Serial No. NA3-10-032R
Docket No. 52-017
COL/MWH

DOMINION VIRGINIA POWER
NORTH ANNA UNIT 3 COMBINED LICENSE APPLICATION
RESPONSE TO REQUEST FOR ADDITIONAL INFORMATION LETTER 50

RAI 5120 Question 02.02.03-8

QUESTION NO.: 02.02.03-9

Figure 1: Onsite Chemical Storage Locations in Relation to the Unit 3 Main Control Room HVAC Intake

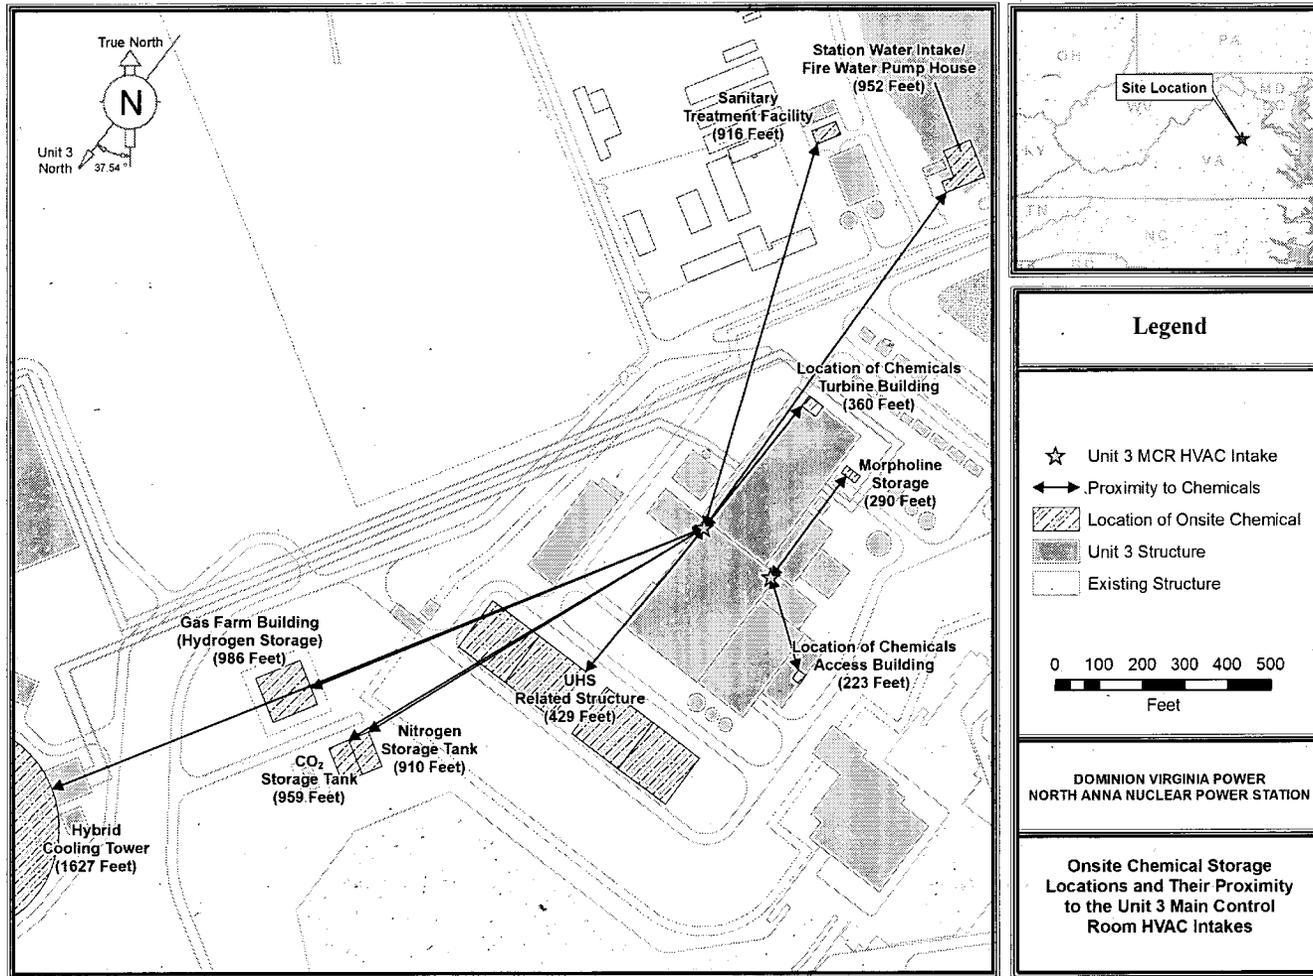
- (1) The NRC staff requests that the applicant provide the input data it used in ALOHA modeling of carbon dioxide concentrations at the control room air intake and provide the rationale for using an urban or forest roughness factor selected in ALOHA modeling compared to the open country option used for on-site chemicals stored at Units 1 and 2.
- (2) The NRC staff requests that the applicant provide rationale and justifications for using the ALOHA model instead of the HABIT model identified in the guidance provided in RG 1.78, and provide the concentrations of chemicals at the control room air intake along with the concentration in the control room for comparison.

The degree of atmospheric turbulence influences how quickly a chemical cloud moving downwind will mix with the air around it and be diluted. Friction between the ground and air passing over it is one cause of atmospheric turbulence. Because the air nearest the ground is slowed the most, eddies can develop. The rougher the ground surface, the greater the ground roughness (Z_0), and the greater the turbulence that develops. "Urban or Forest" ground roughness was selected for the determined worst case meteorological class for the following Unit 3 chemicals stored on-site: acetone, ammonium hydroxide, carbon dioxide, dimethylamine, ethanol, hydrazine, hydrochloric acid, nitrogen and sodium hypochlorite (Access Building only). The selection of "Urban or Forest" is appropriate because the releases at the indicated chemical's storage locations would require a resultant vapor cloud to travel between/around the Unit 3 Ultimate Heat Sink structures (for those chemicals not in the Turbine Building) or around/between structures (e.g., pipes and tanks) within the Turbine Building (for those chemicals stored within the Turbine Building). Figure 1 below shows the storage locations in relation to the Unit 3 Main Control Room HVAC intake.

"Open Country" roughness was selected for the remaining chemicals listed in FSAR Table 6.4-201, including the Units 1 and 2 chemicals, because, as depicted in Figure 1, there are no obstructions or roughness elements between these storage locations and the Unit 3 Main Control Room HVAC intake.
